Sutter Energy Center

Petition to Amend #6

97-AFC-2C

Response to Informal Data Requests 10–26

FIGURE IDR-21
SEC Wetland and Biological Resources
Sutter Energy Center

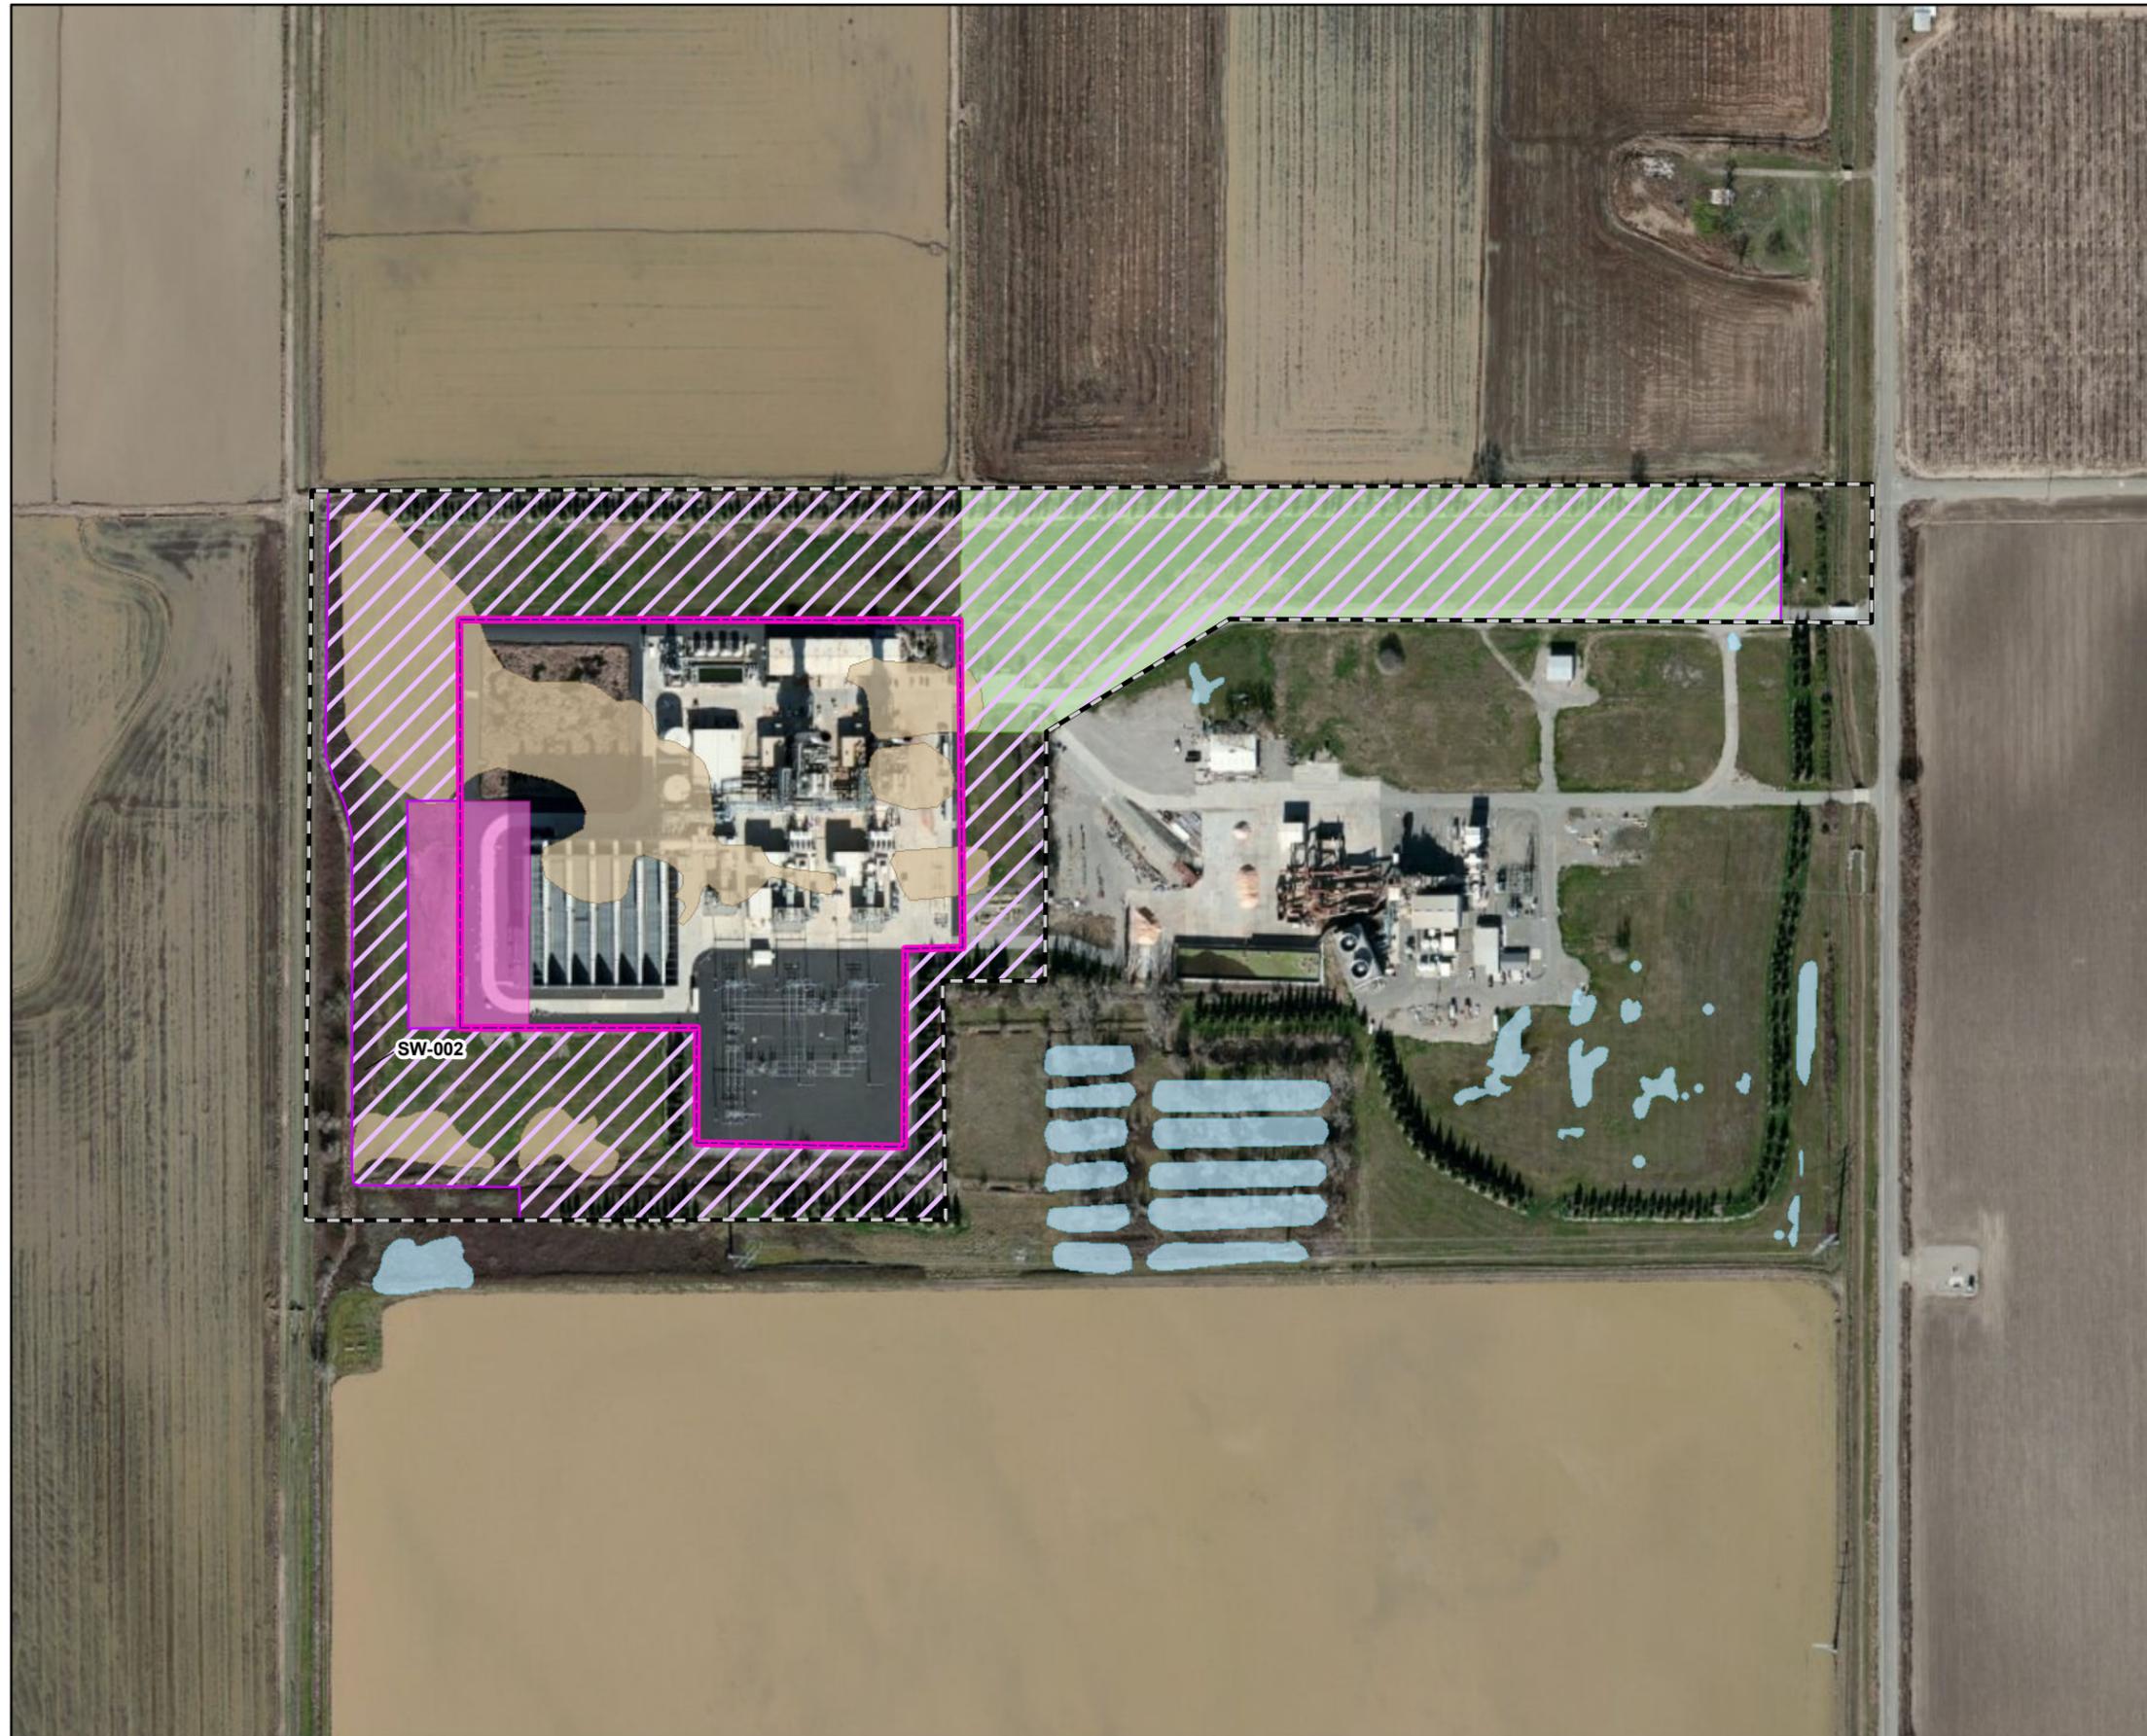
21. *Please provide a figure that shows SW-003, the approximate location of the 5.83-acre wetland area that was previously authorized for fill, the 2.84 acres of wetlands that have been avoided and monitored, the facility's perimeter road and fence line, and the 80-foot wide air-cooled condenser (ACC) expansion area. On this figure, please show which areas outside of the perimeter road and fence line were re-graded after construction of SEC, as indicated on page 3.35 of the Petition to Amend. Please also show any proposed temporary construction staging areas.*

Response: Figure IDR-21 shows SW-003 (label corrected to SW-002), locations of the on-site, pre-construction wetlands, the perimeter and fenceline, the ACC expansion area, the areas re-graded after SEC construction, and the construction staging area for the ACC expansion.
